## SUNDRY NOTICES AND REPORTS ON WELLS

Pan Am Pardue ALZ Federal Com 1

EOG Resources, Inc. requests an extension for the NOI to P&A that was submitted 6/6/16, approved 6/7/16 and expired on 9/7/16. EOG will plug the well as per the COA's from the BLM and a copy is attached.

Yates Petroleum Corporation plans to plug and abandon this well as follows:

WELL NAME: Pan Am Pardue ALZ Federal Com #1 FIELD: Indian Basin U Penn  
 LOCATION: Sec. 27 21S-24E, 1140 S/1350'W Eddy County  
 GL: 4060' ZERO: KB: 4078'  
 SPUD DATE: 12-28-68-DA 1-28-66 RE 4-27-93 RE- COMP 6-11-93  
 COMMENTS: API # 30-015-10728

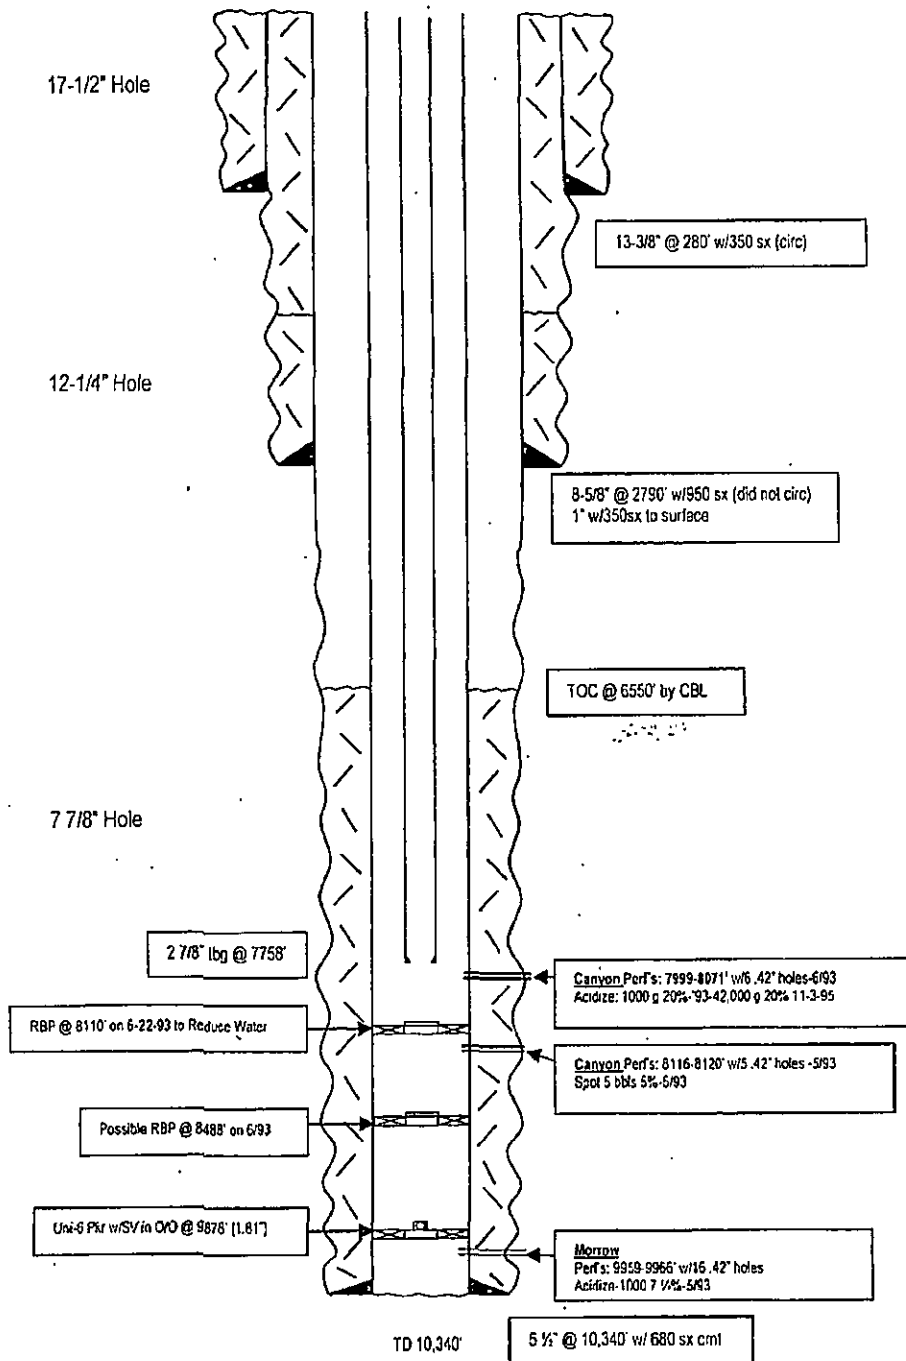
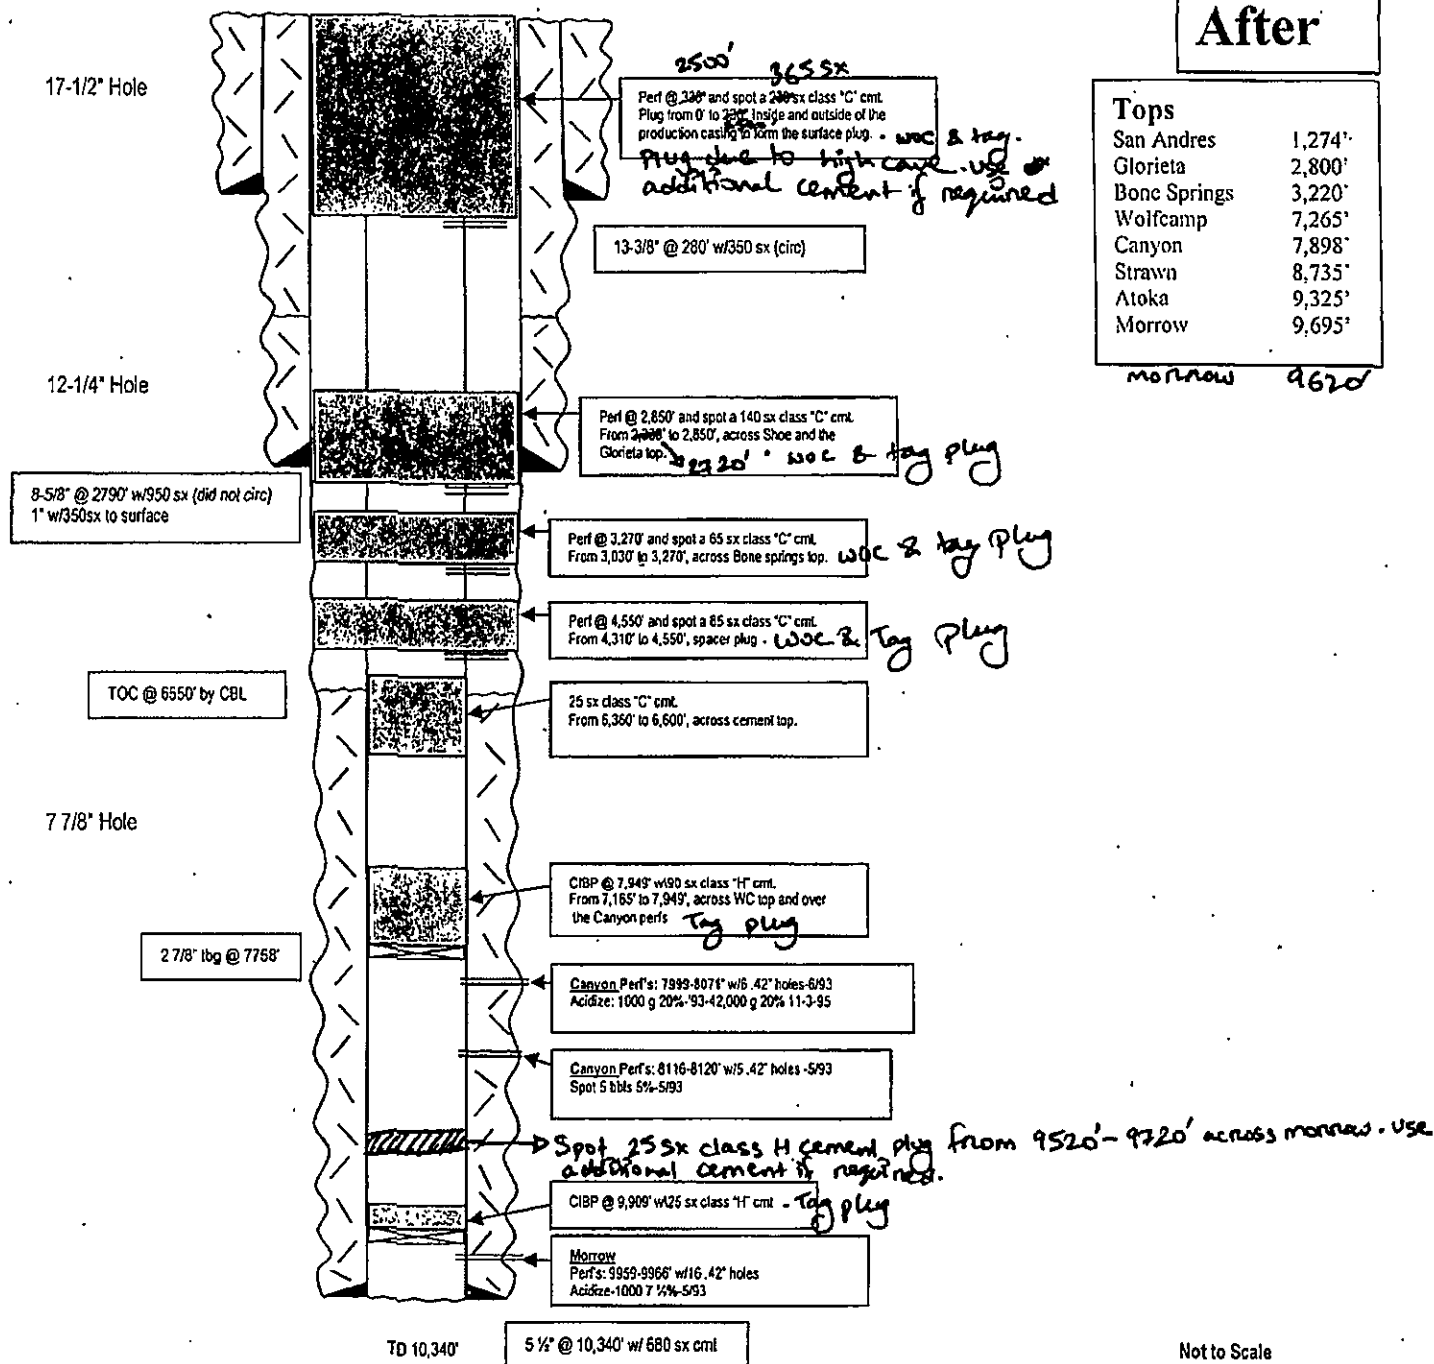
1. MIRU any safety equipment as needed. NU BOP. No casing recovery will be attempted. POOH with tubing and packer and retrieve RBP's at 8110 ft and possibly at 8488 ft. RIH and recover packer at 9878 ft.

2. Set a CIBP at 9909 ft and cap it with 25 sx Class H cement. Tag Plug ~~at~~ spot ~~at~~ 25 sx Class H cement plug from 9520' - 9720' to cover Morrow. vs additional cement if required.

3. Set a CIBP at 7949 ft and cap it with 90 sx Class H cement. This will place a plug across Wolfcamp top and over open Canyon perms. Tag Plug

4. Spot a 25 sx Class C cement plug from 6360 ft - 6600 ft. This will leave a plug across the cement top.

5. Perforate at 4550 ft and spot a 65 sx Class C cement plug from 4310 ft - 4550 ft, inside and outside the casing to form a spacer plug. WOC and tag plug, reset if necessary.

6. Perforate at 3270 ft and spot a 65 sx Class C cement plug from 3030 ft - 3270 ft, inside and outside the casing to form a plug across Bone Spring top. WOC and tag plug, reset if necessary.

7. Perforate at 2850 ft and spot a 140 sx Class C cement plug from 2550 ft - 2850 ft, inside and outside the casing to form a plug across Glorieta top and casing shoe. WOC and tag plug, reset if necessary.

8. Perforate at 230 ft and spot a 200 sx Class C cement plug from 0 - 230 ft, inside and outside the casing to form surface plug. WOC and tag plug, reset if necessary.

*Due to high cave. use additional cement if required*
